## DEVELOPMENT and PLANNING SERVICES COMMITTEE

June 05, 2017

City of Salmon Arm

**BC LAND SURVEYOR'S BUILDING LOCATION CERTIFICATE**

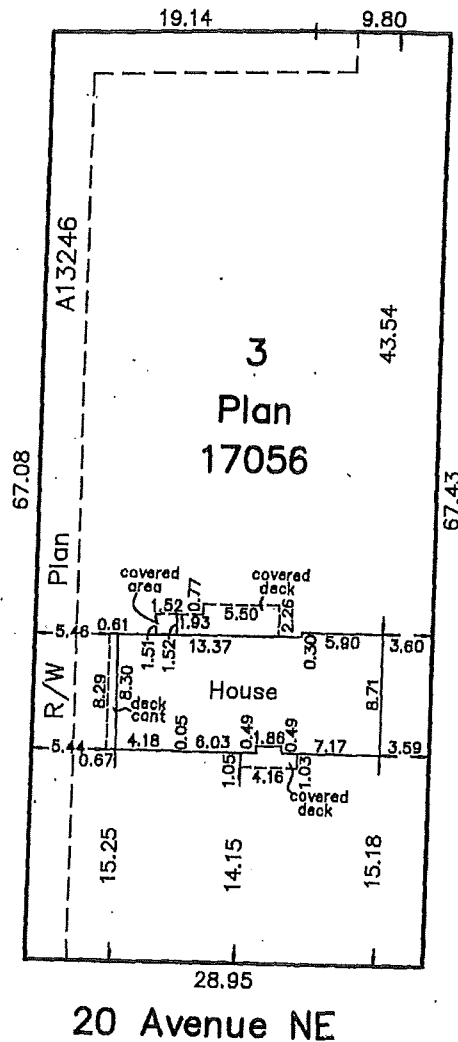
**Engineering Department has no objection to the proposed variance to reduce setbacks.**

20 Avenue NE frontage is currently constructed to a Rural Local Road standard. Upgrading the subjects property frontage to an Urban Collector Road standard, in accordance with Specification Drawing No. RD-3 is required. Upgrading may include, but not limited to, road widening and construction, curb & gutter, sidewalk, boulevard construction, bike lanes, street lighting, and street drainage.

Sidewalks shall be provided on both sides of all collector roads. Currently a sidewalk and curb and gutter is constructed on the south side of 20 Avenue NE only. Installation of sidewalk on along the property frontage is required, and will promote connection of existing sidewalks on 30 Street NE and potentially other future subdividing within the area. As this work is considered pre-mature, a cash contribution would be accepted for the supply and installation of concrete curb & gutter and sidewalk.

Existing street lights are BC Hydro lease lights on the hydro poles on the south side of 20 Avenue NE. It is required to install post top Ornamental Street lighting along the property frontage.

**The City of Salmon Arm Engineering Department recommends this variance request be denied and a cash contribution of 100% for the road upgrades be required.** City Engineering Department does not believe this amount is unreasonable for a subdivision of a lot within the City of Salmon Arm.

DRAWING TITLE:  
**SECOND FLOOR PLAN**

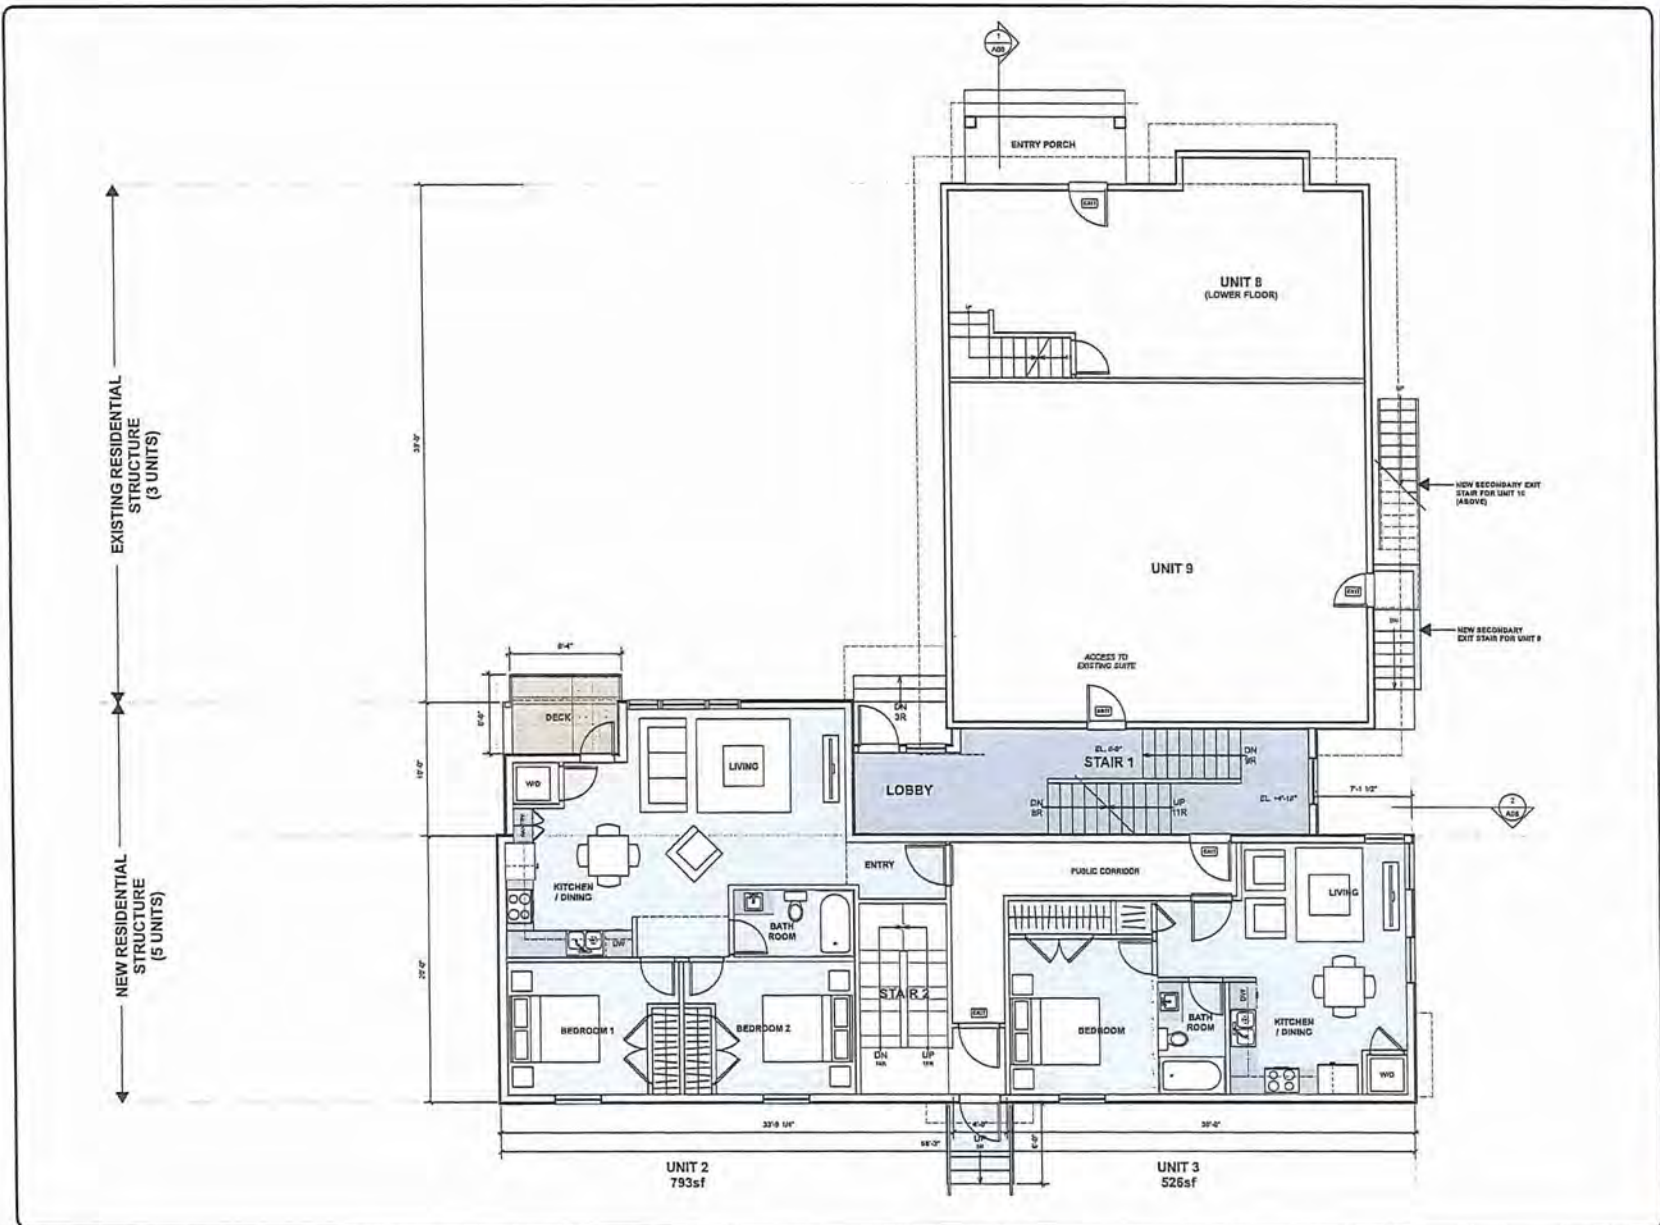
Staff agree with the DRP recommendation, noting this reduces the "small car" variance requested. The applicant has adopted the suggestion in response. The attached site plan reflects this change.

as proposed is just shy of the 13 required (1.25 parking spaces per dwelling unit), while the 42% (5) small parking spaces proposed is greater than the 20% (2) permitted, as specified by the Zoning Bylaw. Variances have been requested to address these deficiencies. Given the proximity of the subject property to downtown, staff feels the request for a reduced total number of parking spaces (13 to 12) is reasonable, however it is of note that street parking and snow storage are very limited at this location. Planning staff are not concerned with the request for an increased number small car parking spaces, however, aligned with the Engineering Department's comments, note that the location adjacent to the lane is not ideal and would require diligent attention from the building manager with respect to allotting the spaces to small cars only, and in removing snow during the winter so the depth of the parking stalls is not seasonally reduced.

3. The proposed parking from the laneway must ensure that parking is feasible without an overhang into public roadway; submission drawings currently show overhang. As per Zoning Bylaw No. 2303 parking stalls shall have a length of 5.8 meters
4. All boulevards shall slope towards roadway at minimum 2.0%
